Report Committee of Adjustment

File: A-2023-0219

Address: 3 Gladiolus Street

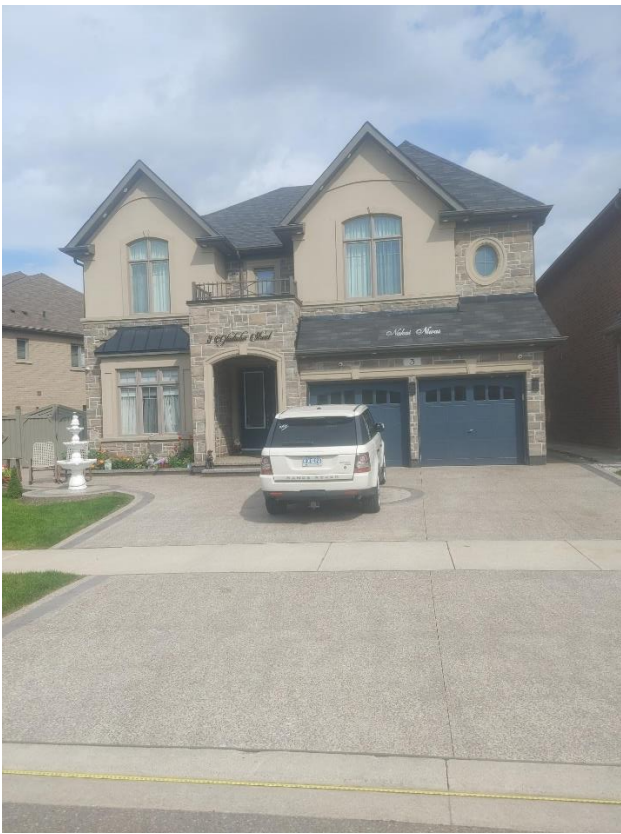
Variance 1 is requested to permit a driveway width of 8.01 metres (26.27 feet) whereas the by-law permits a maximum driveway width of 7.32 metres (24.06 feet). The intent of the by-law in regulating the maximum permitted driveway width is to ensure that the driveway does not dominate the front yard landscaped area and that the driveway does not allow excessive number of vehicles to be parked in front of the dwelling. Despite the increased driveway width of 0.69 metres (2.26 feet), Staff are able to support the variance as the increase does not permit the parking of additional vehicles and a path to the front entrance of the dwelling is maintained. The applicant will not need to decrease the permeable landscaping that abuts adjacent property and permanent flower bed fixtures will be added to the front yard, as depicted in the revised Site Plan (Appendix B). Subject to the conditions of approval, Variance 1 is considered to maintain the general intent and purpose of the Zoning By-law.

Variance 1 is requested to permit an existing driveway width which exceeds the requirement that is set out in the Zoning By-law. The applicant is seeking to increase their driveway width by 0.69 metres (2.26 feet). The expanded driveway will not facilitate parking of additional vehicles and it will not have a negative impact on the streetscape as permeable landscaping features will remain. The applicant has provided a Site Plan which depicts the use of flower beds on a portion of the front yard, creating a barrier that separates the curved design of the front yard. A condition has been included in the report, stating that the applicant should provide Staff with documentation of the final driveway condition, inclusive of the width measuring 8.01 metres (26.27 feet). Documentation should also include the

reinstatement landscaped areas as depicted on the Site Plan (Appendix B) and it should be completed within 60 days of the Committee's decision or within the given extended period of time. To ensure that the proposed reinstatement of the landscaped areas will be permanent, a condition has been included in the report stating that the fixtures shall not be removed, but may be repaired when necessary. Subject to the recommended conditions of approval, Variances 1 is appropriate for the development of the land.

Variance 1 is requested to permit an increased driveway width in the front and beyond the dwellings main entrance. The variance that is being requested is not considered to be one that will significantly impact the amount of available outdoor amenity space, permeable landscaping or significantly affect drainage on the subject property or adjacent properties. Permanent planting mechanisms have been included in the Site Plan which will ensure that a path to the front entrance is not obstructed. Due to the size of the addition (0.69 metres) and inclusion of the flower beds in the front yard, the requested variance is not considered to be minor in nature.

3. That the applicant provide Staff with documentation of the final driveway condition inclusive of the width measuring 8.01m (26.27ft.) and reinstatement landscaped areas as depicted on Appendix B within 60 days of the Committee's decision or within an extended period of time at the discretion of the Director of Development Services;

4. That the proposed reinstatement of the landscaped areas as depicted in Appendix B and reduced driveway width to 8.01m shall be maintained, and shall not be removed, but may be repaired when necessary;
